## Twin Falls Fire Station 2 Addendum #3 CRA# 2020-538 February 21, 2022

Project: TWIN FALLS FIRE STATION 2

Sheet No:  
**E2.21**

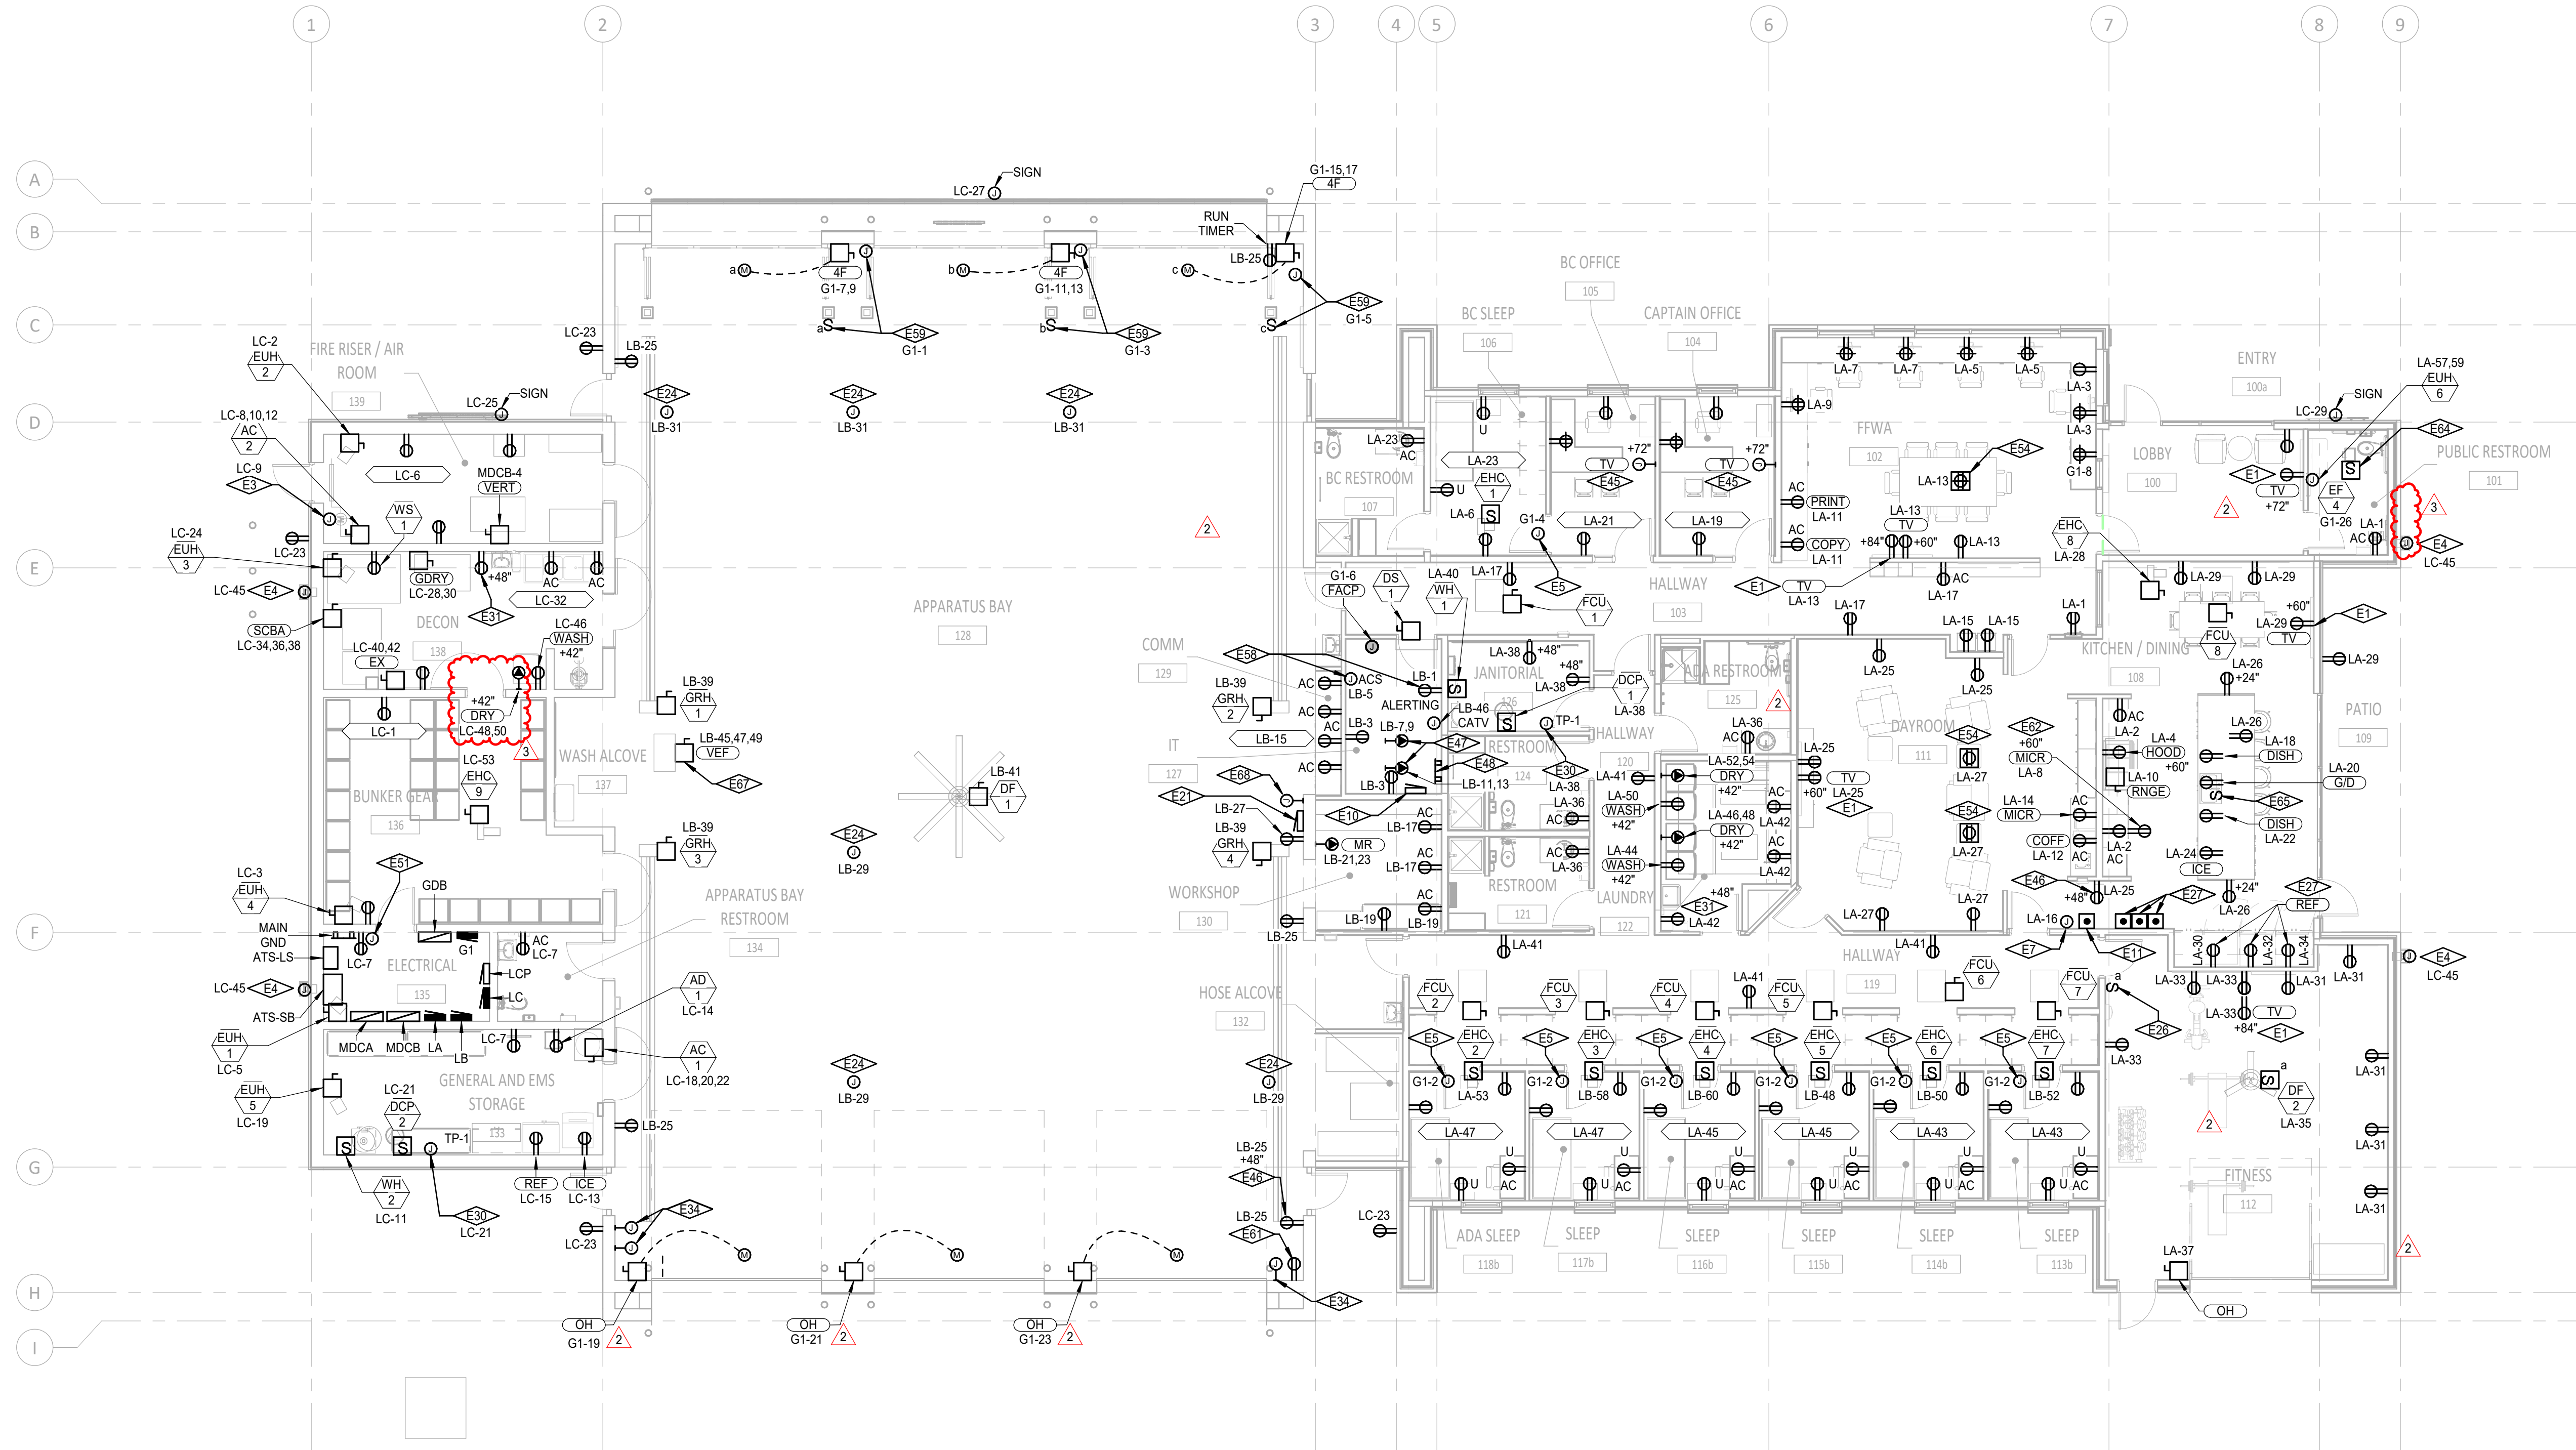
SHEET E2.11 - Level 1 - Lighting Plan - REPLACE IN ITS ENTIRETY	
<b>ADM #.7</b>	Assigned correct lighting control method for recessed exterior lights.
SHEET E2.21 - Level 1 - Power Plan - REPLACE IN ITS ENTIRETY	
<b>ADM #.8</b>	Added receptacle for stacked dryer in Decon room.
<b>ADM #.9</b>	Relocated junction box for heat trace to match updated roof drain location.

Sheet No:  
E2.31

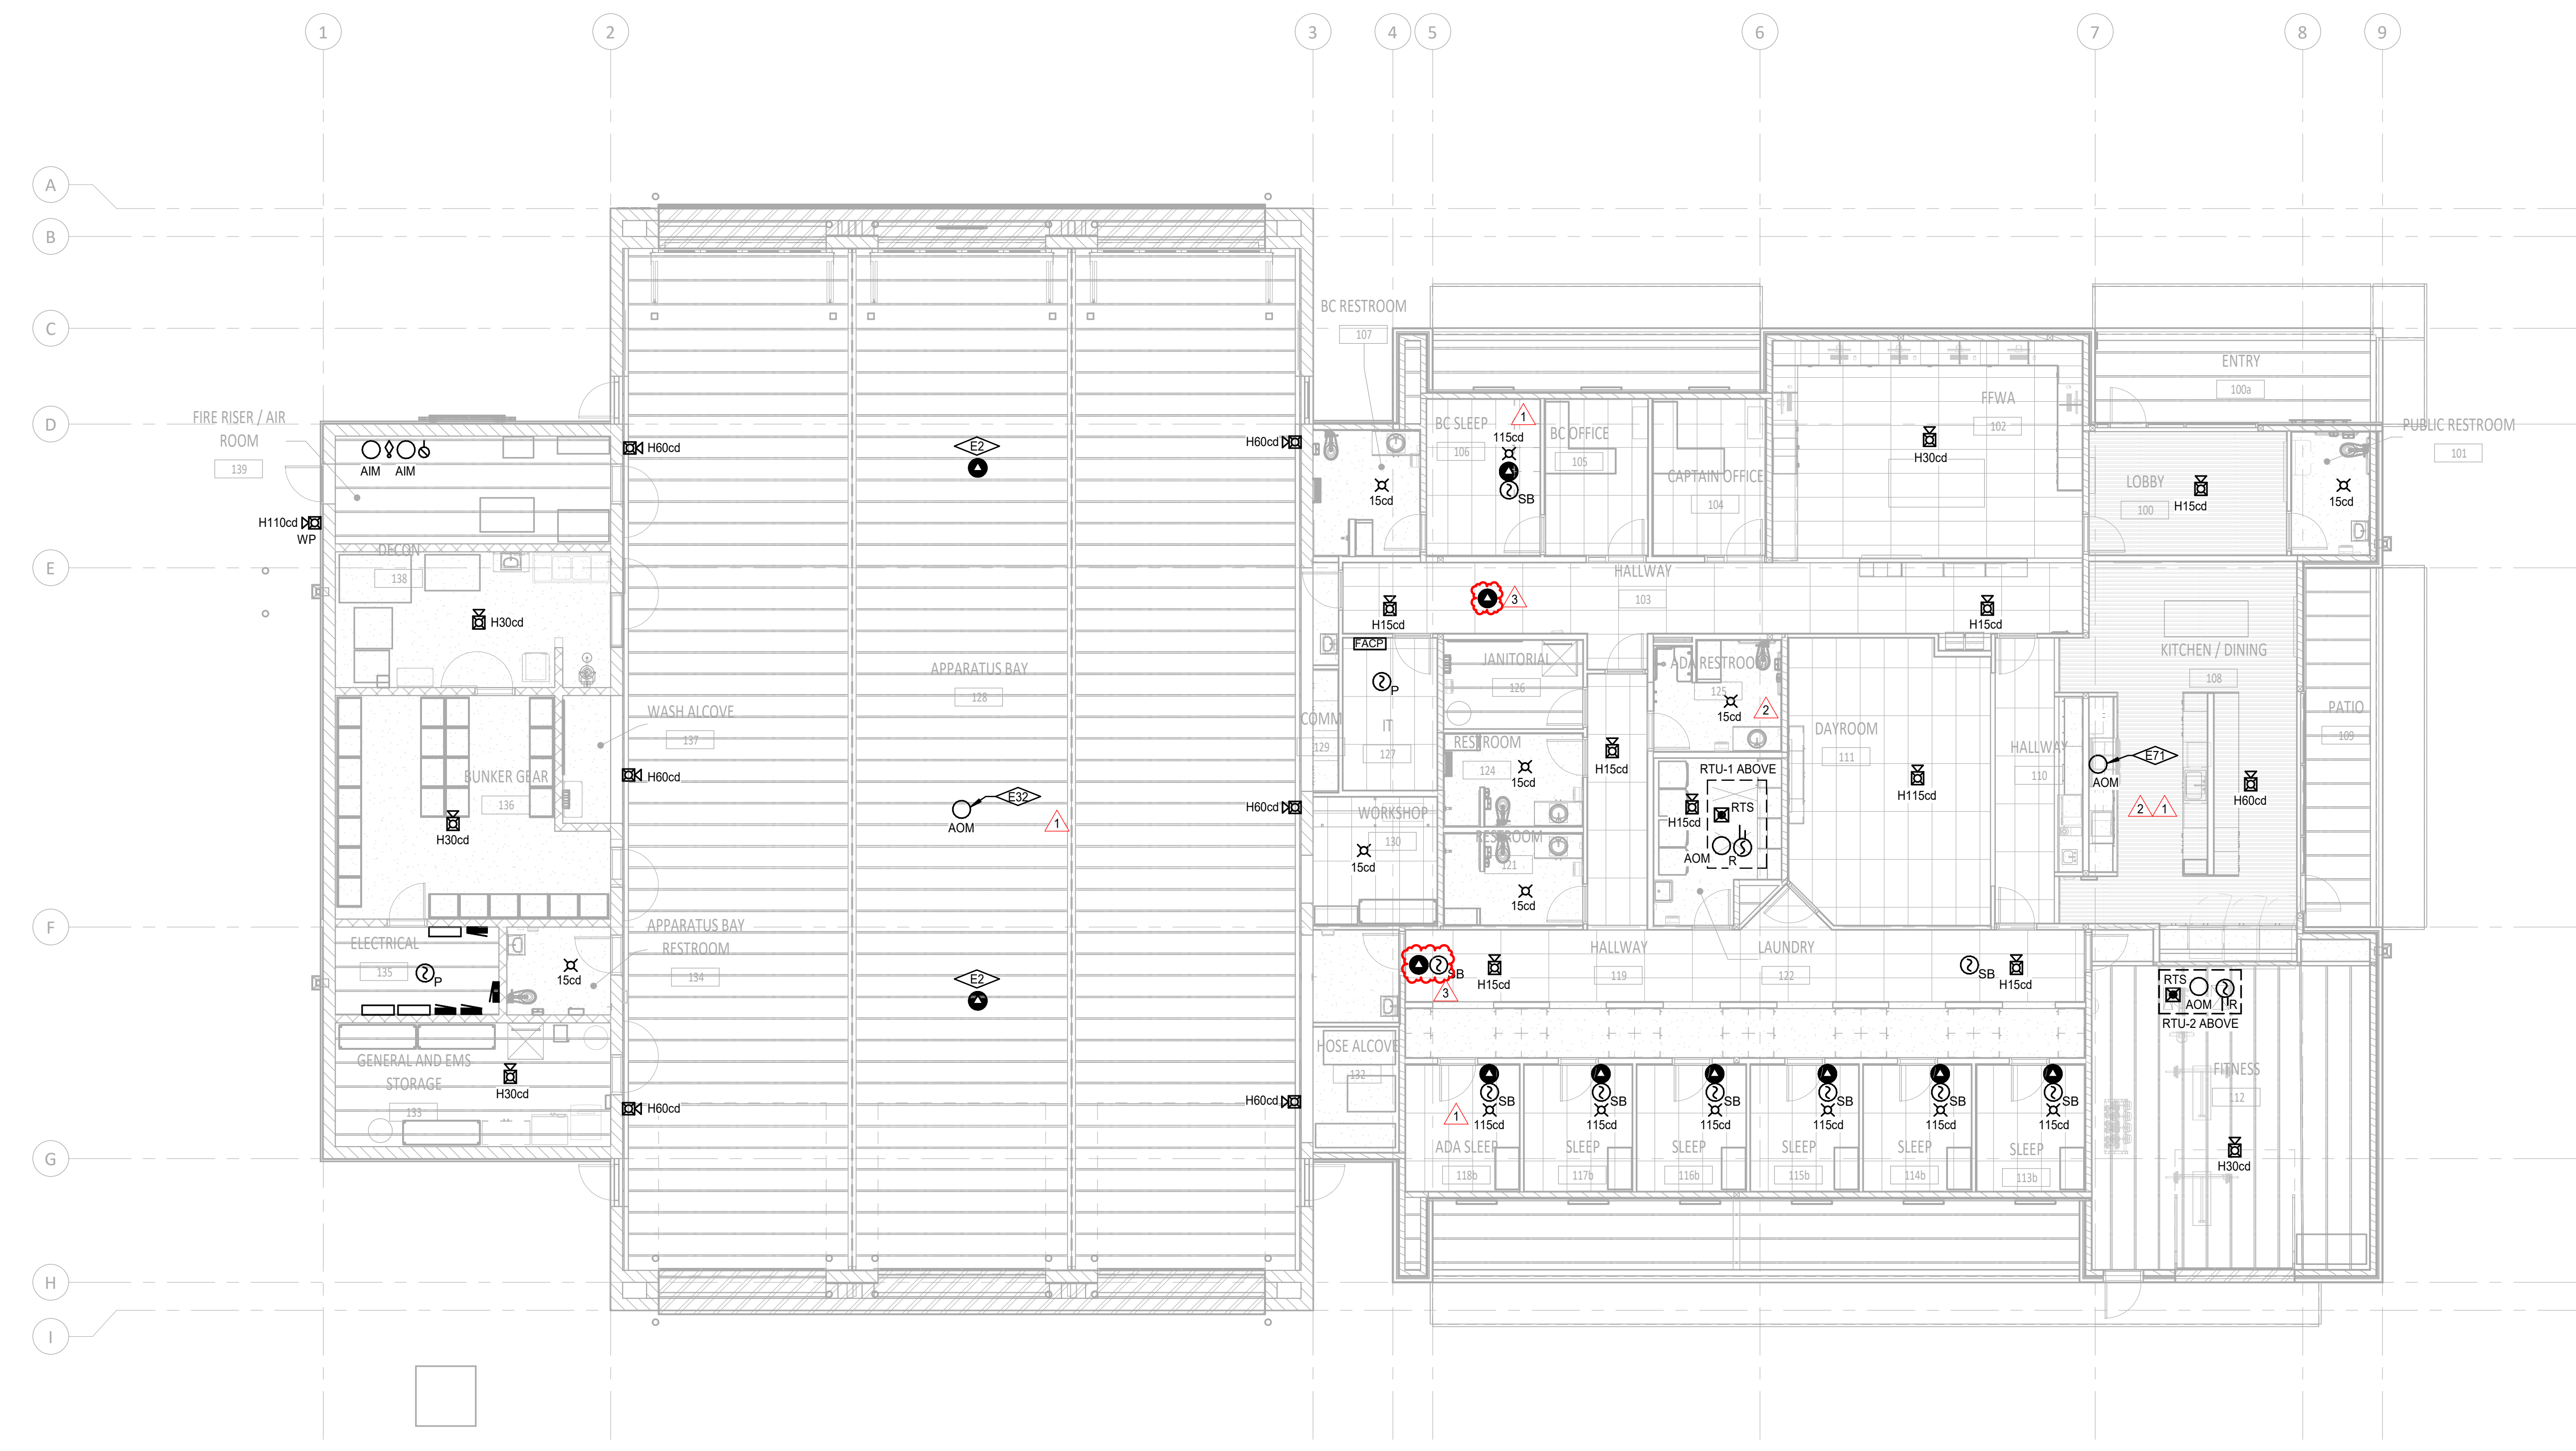
SHEET E2.31 - Level 1 - Fire Alarm Plan - REPLACE IN ITS ENTIRETY	
<b>ADM #.10</b>	Added carbon monoxide sensors to hallways connecting sleep rooms to apparatus bay to comply with NFPA 72.

Sheet No:  
T2.21

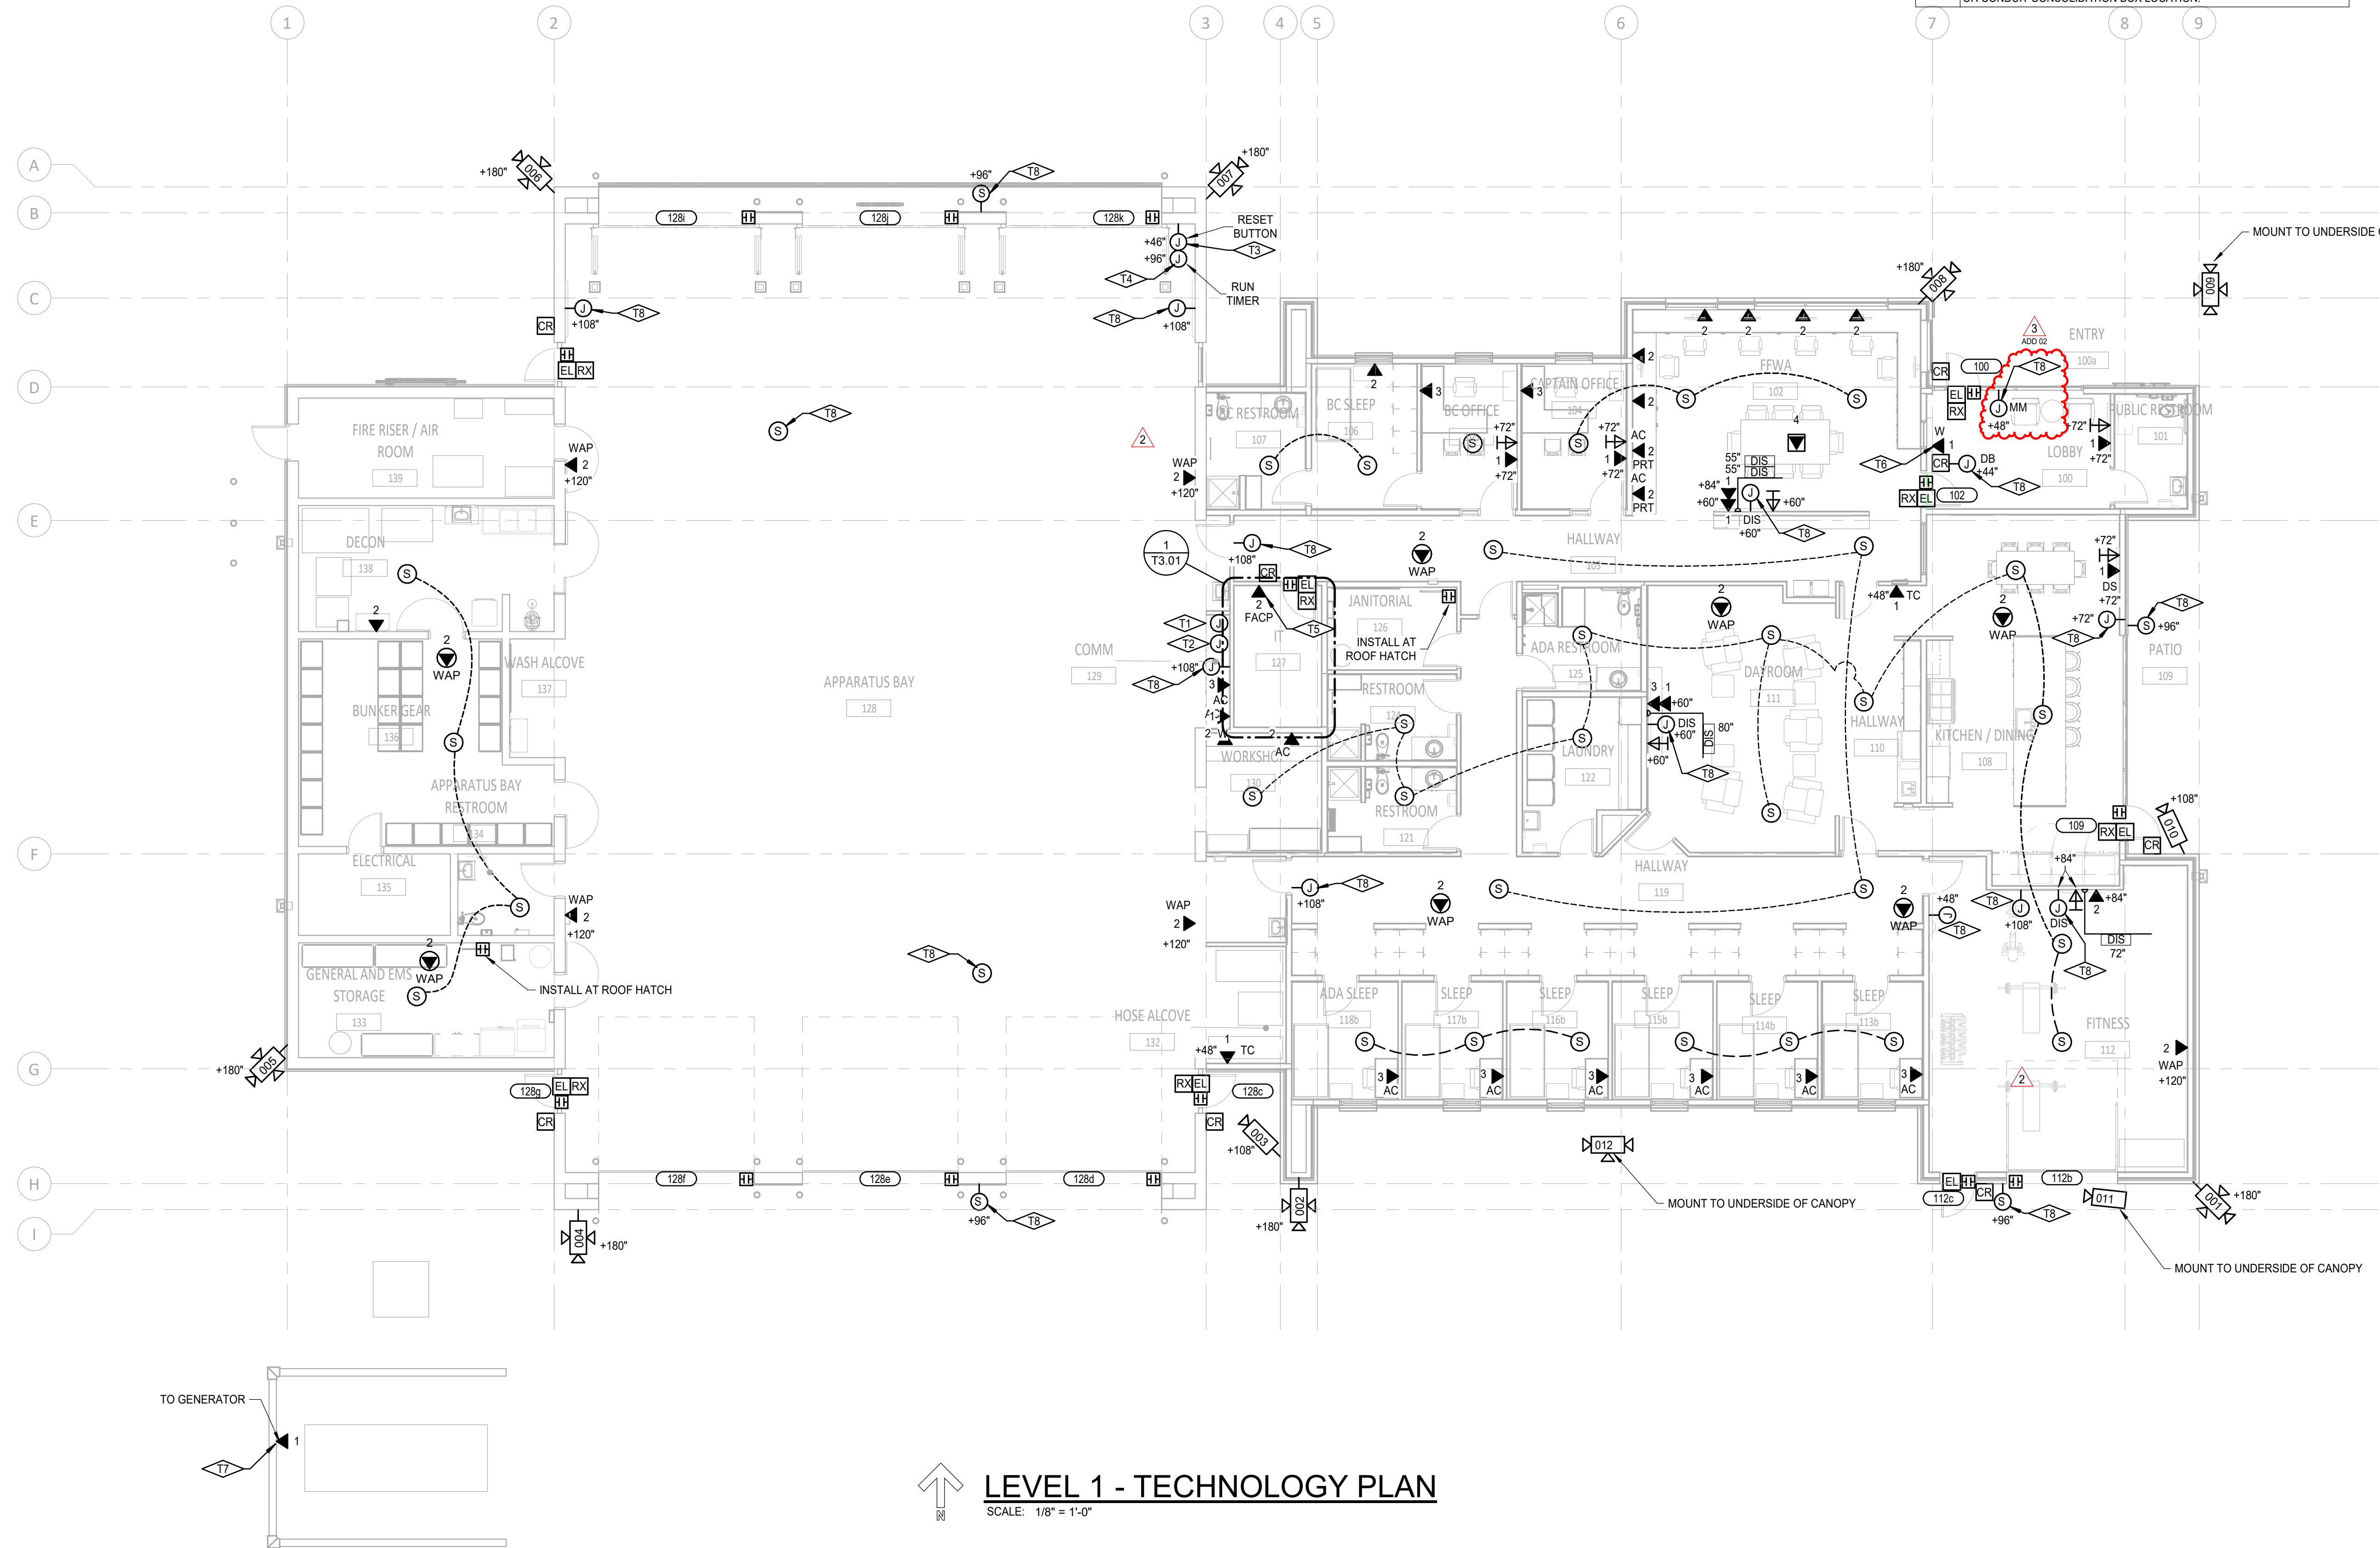
<b>TECHNOLOGY DRAWINGS</b>	
<b>SHEET T0.01 – Technology Legends &amp; Notes Schedules – REPLACE IN ITS ENTIRETY</b>	
<b>ADM #.14</b>	Added abbreviation for mullion mount.
<b>SHEET T2.21 – Technology Floor Plan Series – REPLACE IN ITS ENTIRETY</b>	
<b>ADM #.15</b>	Relocated alerting system button in entry vestibule.
